West Oaks Matrix of Retrofits to Covered Unit Interiors

West Oaks Apartments: Covered Unit Interiors

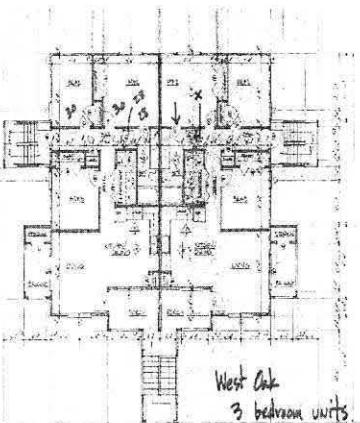
Numbers	Inaccessible Features at Covered Dwelling Units Photos	Deficiency	Required Retrofit
1		Covered dwelling units have inaccessible knob type hardware that requires tight grasping, pinching, and/or turning.	Install accessible lever door hardware at all covered ground floor dwelling units where the existing hardware is knob style to comply with ANSI 4.13.9.
	Required retrofits associated with the below line items shall be performed at 10 first floor units, eight two-bedroom units and two three-bedroom units. The units are as follows: Flavion Drive Building Units 101, 102, 103, 104, 105 and 106; Building 2100, Units 101 and 102; and Building 2117, Units 101 and 102. See Accessible Route Plan.		
2		Thermostats are mounted higher than 48" above finished floor.	Lower thermostats to comply with Requirement 5.
